ARCHITECT'S SUPPLEMENTAL INSTRUCTIONS

PROJECT:	The Residence at Green Meadow New Senior Development San Angelo, TX	Report No.	Nine (9)
OWNER:	Overland Property Group Dan Maximuk 234 N. Santa Fe Ave, Suite A Salina, KS 67401	Date	August 19, 2025
CONTRACTOR:	MCP Group 3501 SW Fairlawn Rd. Topeka, KS 66614	Architect's Proj No.	24-3395
		Contract For:	General Construction Mechanical, Electrical

1. Revised Arch Sheets: A2.7, A8.1
2. Revised Specification Section 108500 Building Specialties

A ENLARGED "CLUBHOUSE" FLOOR PLAN
1/4" = 1'-0"

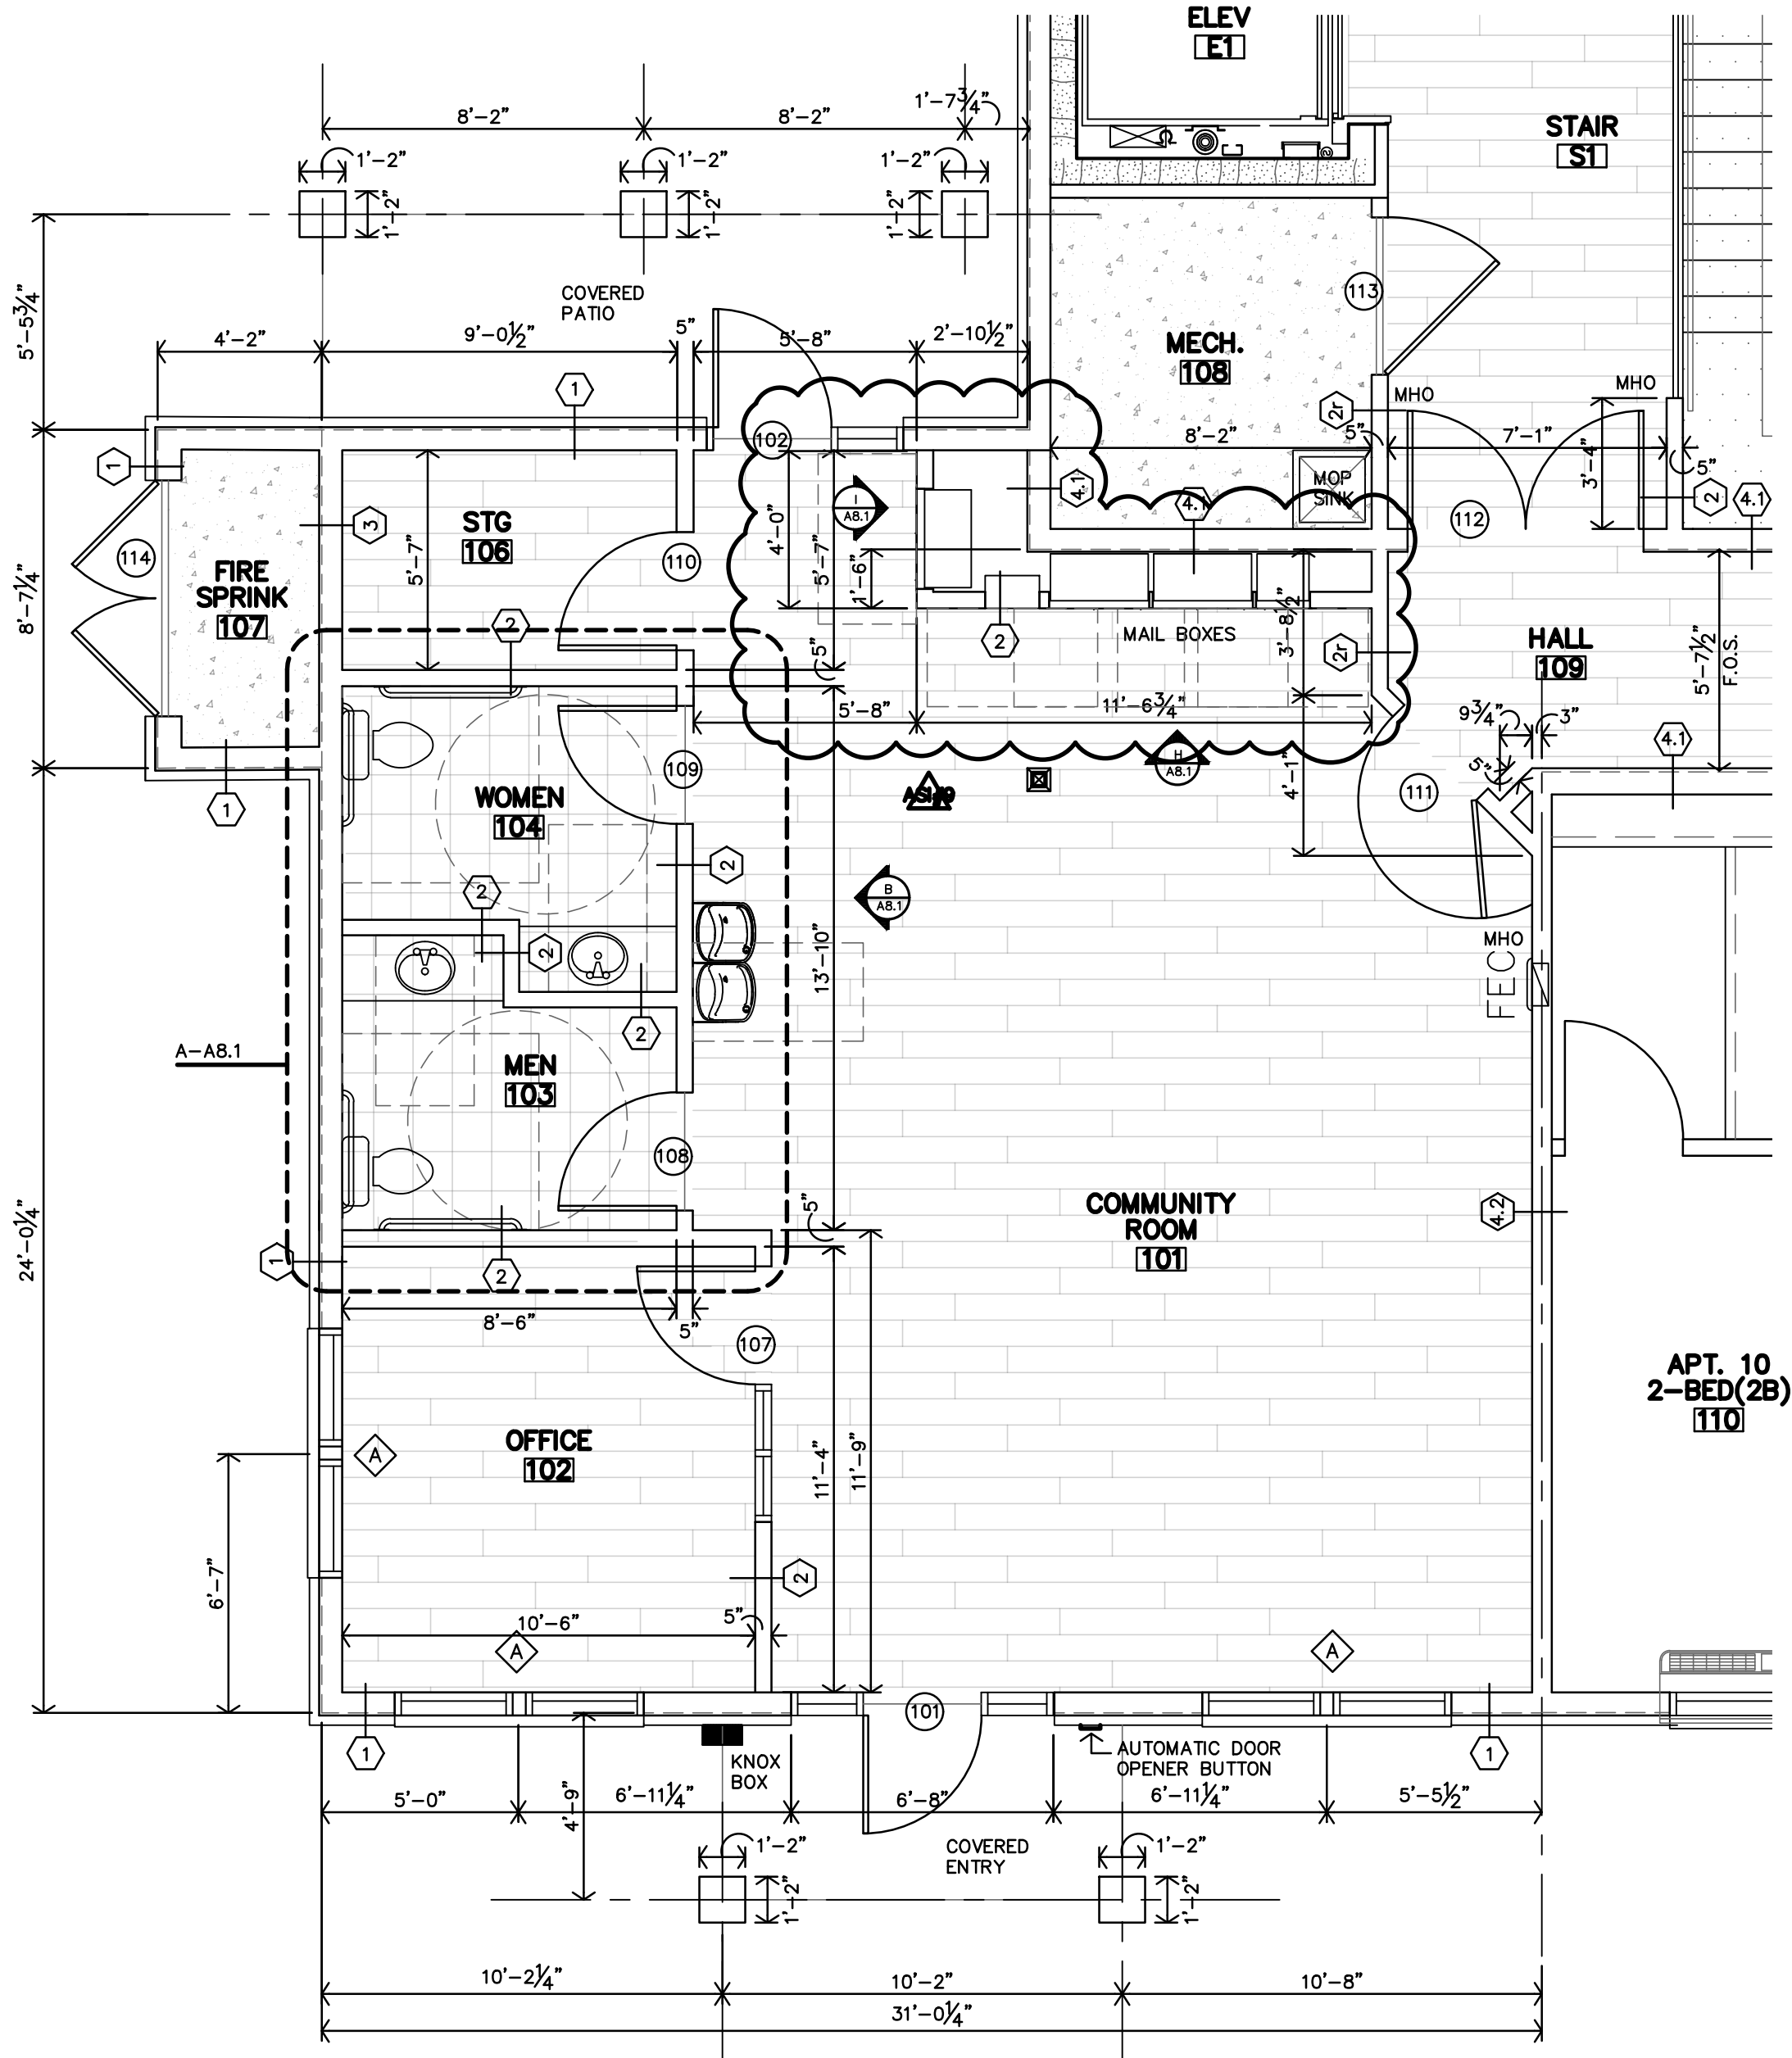
- a. Change mailbox models to (3) 4CADD-09 & (1) 4CADS-04 units from Florence Manufacturing Company.
- b. Shift west mail area wall towards Door 102 by 14" to allow for installation of additional mailbox.
- c. Move in-house mail slots to the west end of the south wall.
